## Public Opinion seems to be the only recourse to getting action from LLTNP

Our ref: snpa17/041 16/07/17

Complaint regarding handling of the camping development at Loch Chon

STORE ROOM / RANGER BASE  
END ELEVATION 1:50

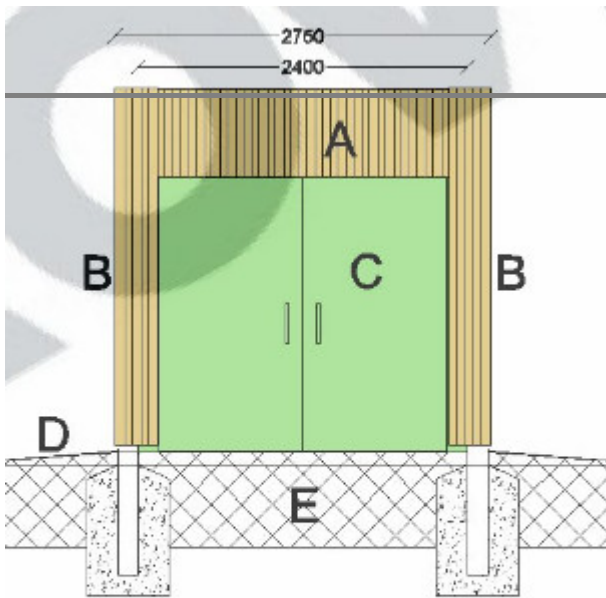
2. The containers used for the Rangers Base and the water purification plant do not correspond with the engineering drawings in respect to the size and finish to the end elevations shown in your documentation.

In both instances the doors fitted are taller than those specified which in turn has prevented fitting a wooden facing above them as specified.

In the case of the Ranger Base Store end the door fitted is larger and of a different design with locking bars on the surface which are totally unsuitable as a solution in this sensitive site.

The wood cladding to the exterior of the containers do not conform to the engineering drawings, the posts and concrete ground supports have not been fitted with the cladding being applied to the container surface directly, this contravenes the design specification and the resultant aspect is an industrial container which has no place in this sensitive area.

Intake Port.

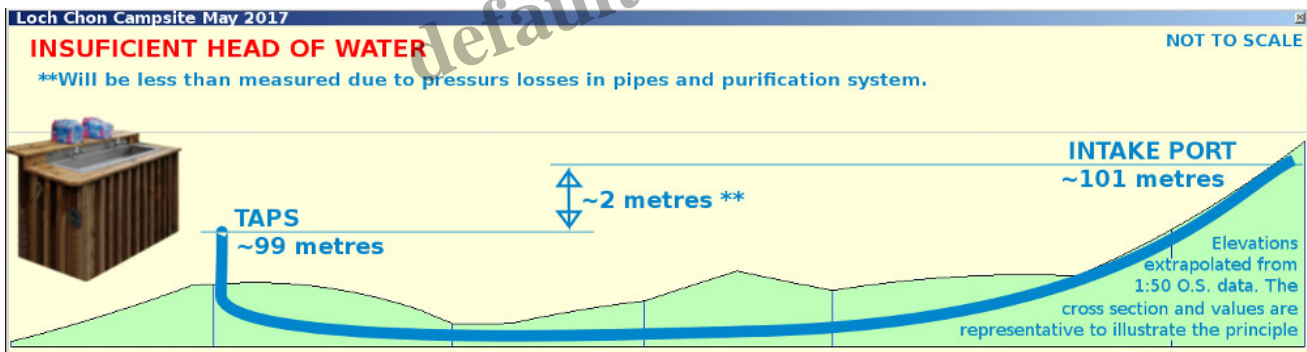
The original drawings which you have removed from your system showed the water intake upstream from it's current location as shown here, it is clear that this was the intended position due to pipe clips and small rock built dam.

Due to a failure of the planning department to insist on construction drawings detailing the construction of the necessary reservoir or header tank, or the selection of a suitable natural alternative, to guarantee a sufficient head of water to operate the system, the applicant was not constrained. Their contractor fitted the intake pipe, in good faith, at a location that was later to prove unsuitable as the water level in the stream dropped in dry weather leaving the intake above the water level. This was however the location agreed in the planning consent and it would seem no proper evaluation or calculations of the technical requirements for the intake were carried out to support this location, not least the need to be underwater.

The new location for the intake port is under the culvert, I

would think a wholly unsuitable location due to it interfering with the requirement to have a smooth unimpeded surface in the culvert to stop build up of debris.

The resultant head of water has been reduced by a meter or so exacerbating the situation where this reservoir needs to be placed upstream to increase water pressure.

The moving of the intake pipe downhill is in breach of planning consents as an NMV would not be adequate to cover a change requiring calculations and of water heads and pressures at the output of the sterilisation system.
